# **Review Statement and Evaluation of the Swedish Nuclear Fuel and Waste Management Co's RD&D Programme 2004**

Swedish Nuclear Power Inspectorate

Datum/Date  
June 20, 2005

## **SKI's Review Statement on the Swedish Nuclear Fuel and Waste Management Co's RD&D Programme 2004**

Figure 1. Main features of SKB's long-term plan (from SKB's TR-04-21, p. 362).

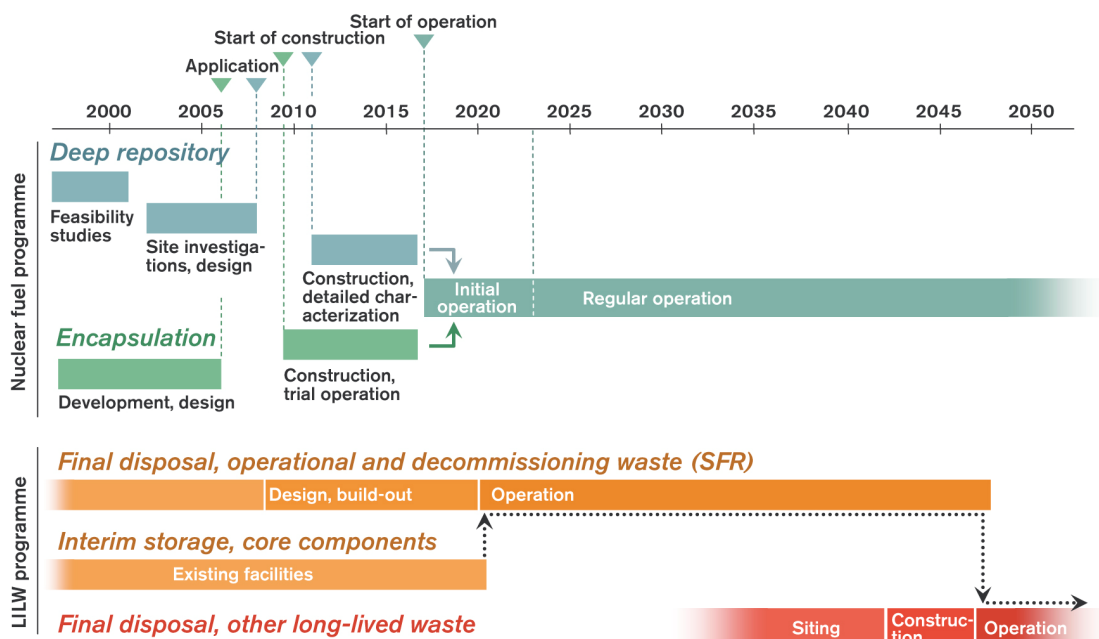
In SSI's view, the account of the system analysis provided in RD&D Programme 2004 is far too brief for it to be possible to distinguish, in detail, SKB's aims with respect to the future system analyses. SSI particularly points out the importance of the links between different system parts and how the operation of the different facilities is to be designed in order to ensure that the initial state of the repository will be as desired.

In summary, SSI considers that SKB should develop its plan of action, and its description, in future RD&D programmes, with a better justification of planned RD&D work on the basis of an analysis of critical remaining research and development issues. Examples of issues that, in SSI's view, should be highlighted in this way include, acceptance criteria for the canister, long-term experiments on buffer and backfill performance, demonstration of deposition methods, evaluation of the initial operating phase (also with respect to the test of barrier performance) and the need for models for the biosphere, climate and rock mechanics.

Figure 2. Licence applications and decision-making process for the repository system (from SKB's TR-04-21, p. 366).

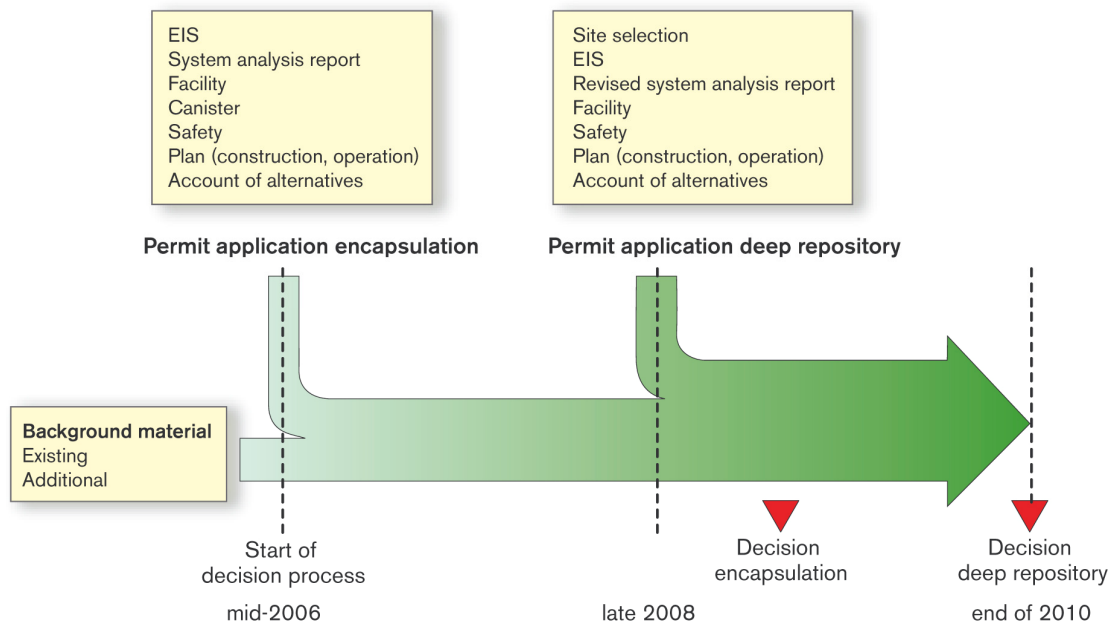
In SKI's view, the description of the supporting documents for the applications (provided in connection with Figure 3 in the appendix) should have focused more on documents that are included in the basis for decision-making and their content.
